VILLAGE OF PALATINE
VILLAGE HALL - COUNCIL CHAMBERS
200 E. WOOD STREET
PALATINE, IL 60067-5339 – (847) 359-9050
<http://www.palatine.il.us>

MINUTES

AUGUST 3, 2020

1. Consider a Motion Approving the Final Fence and Screening Plan Along Hicks Road for the Ayreshire Subdivision (Northwest Corner of Hicks Road & Garden Avenue) - **Approved by Voice Vote** (Council District: Three)

HICKS ROAD LANDSCAPE PLAN

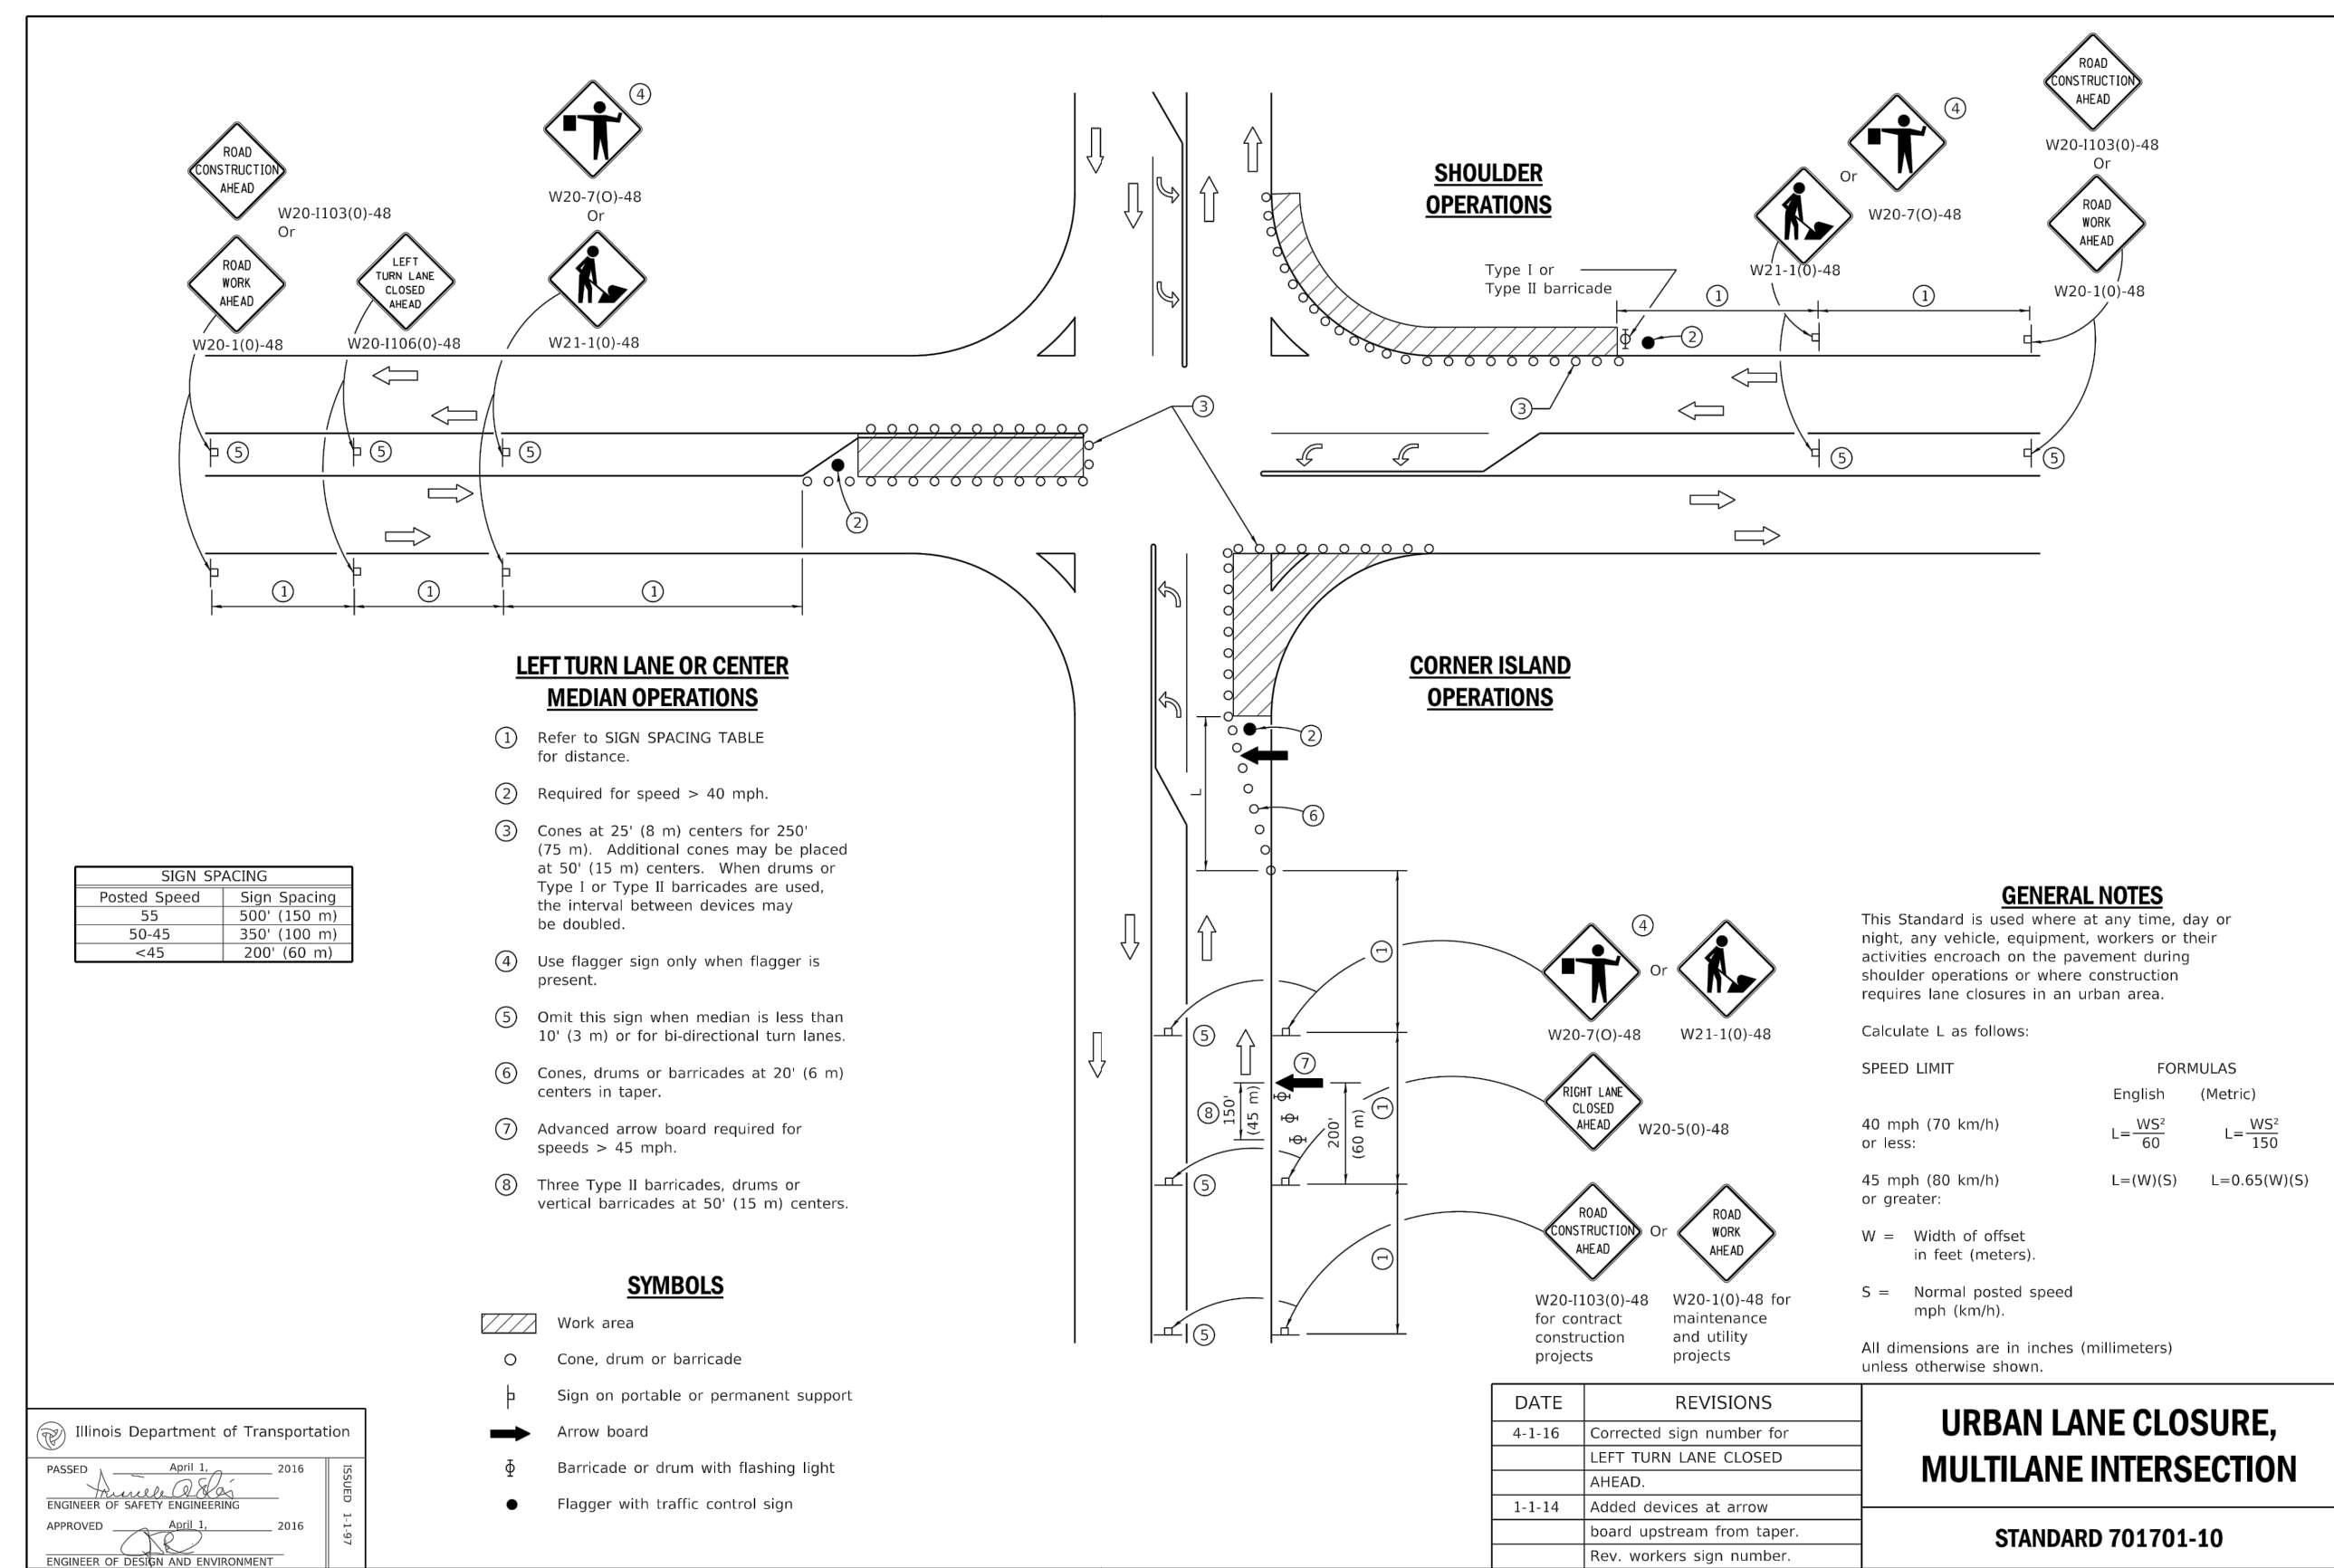
1. The plan should be amended to include plantings on the Hicks Road side of the 6' fence installations. The discussion at the meeting noted a desire by the majority to require plantings on the east side of the fencing sections.

2. There was also direction provided to include a few additional trees/evergreen within the Hicks Road planting. The Village Council also requested to better understand the anticipated mature heights of the shrubbery (redbud, quick fire, dogwood, etc.), as I believe that they wanted to anticipate what the final growth pattern and heights of the planting varieties, in conjunction with the 6 foot solid fence.

3. Tim attested to the IDOT requirement IDOT requirement to replace removed trees in the ROW. After discussing this and reviewing both the ENG plan (sheet 12), the landscaping plans should reflect the re-installation of the parkway trees, per IDOT. This will further answer the landscaping questions raised about screening along the fence sections. As part of that discussion, the Village Council also request that the elevation reflect the grade in the adjacent Hicks Road right-of-way in front of the fencing and landscaping.

Response: Plans have been revised as directed.

Response: Plans have been revised to include the addition of (3) evergreen trees and (1) shade tree (within the Hicks Road planting, off the NEC of building #4). Also, as mentioned below in the response to comment #3, (3) shade trees have been added in the Hicks Road ROW.

Response: Plans have been revised to reflect the incorporation of (3) replacement trees, (3) 3" caliper Sugar Maples (spaced 50' on center). The elevation has also been revised to reflect these (3) trees and the grade of the adjacent Hicks Road right-of-way.
